87C196JR SPECIFICATION UPDATE

Release Date: December, 1998

Order Number: 272858-005

- Check for pending EPAX interrupts before exiting an EPAX ISR

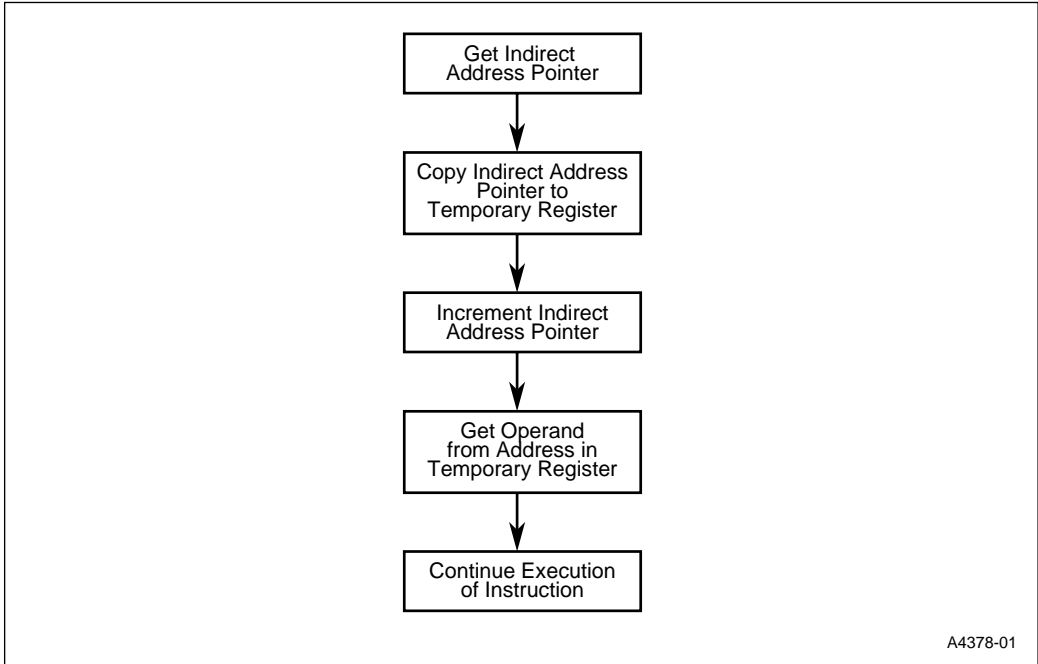
7. *EPA Overruns*

PROBLEM: The EPA can lock up if overruns are handled incorrectly. Overruns occur when an EPA input transitions at a rate that cannot be handled by the EPA interrupt service routine. If no overrun handling strategy is in place, and if the following three conditions exist, a situation may occur where both the capture buffer and the EPAX_TIME register contain data, and no EPA interrupt pending bit is set:

Another method for avoiding this situation is to check for pending EPA interrupts before exiting the EPA interrupt service routine. This is an easy way to detect overruns and additional interrupts. It can also save loop time by eliminating the latency necessary to service the pending interrupt. However, this method cannot be used with the peripheral transaction server (PTS).

Figure 1. 16-bit System with EPROM

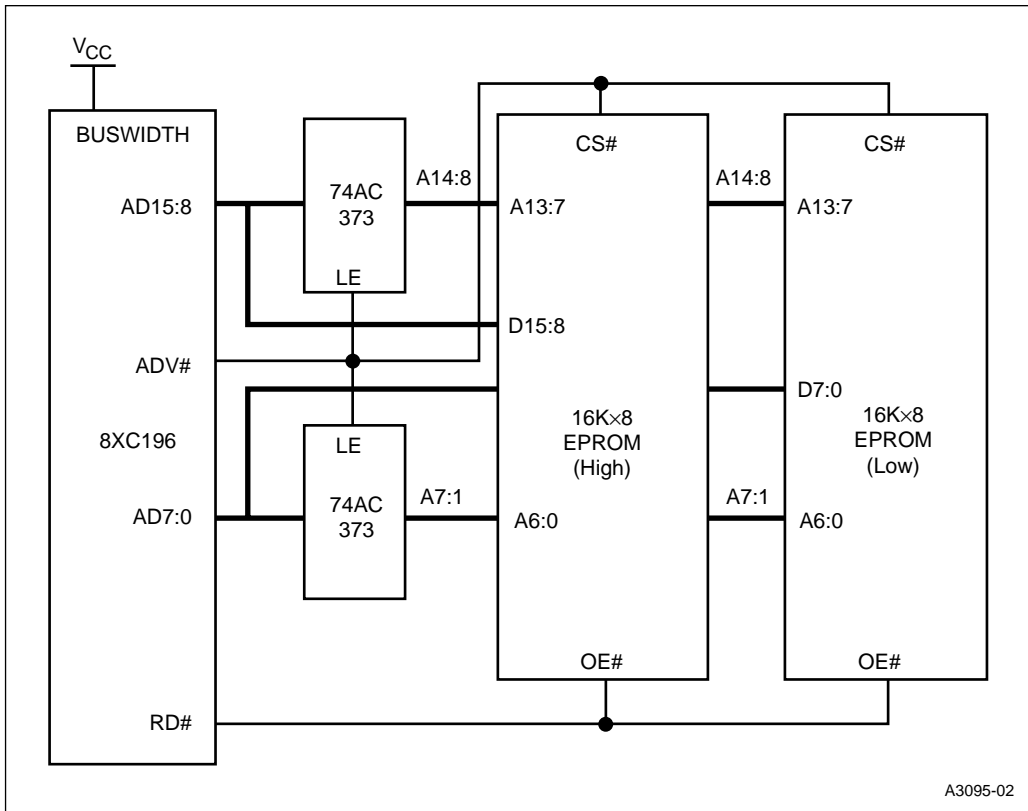
1. **High address inputs to the low EPROM should be A14:8 in Figure 15-18.**

ITEM: The next revision of the user's manual will include the following corrected graphic.
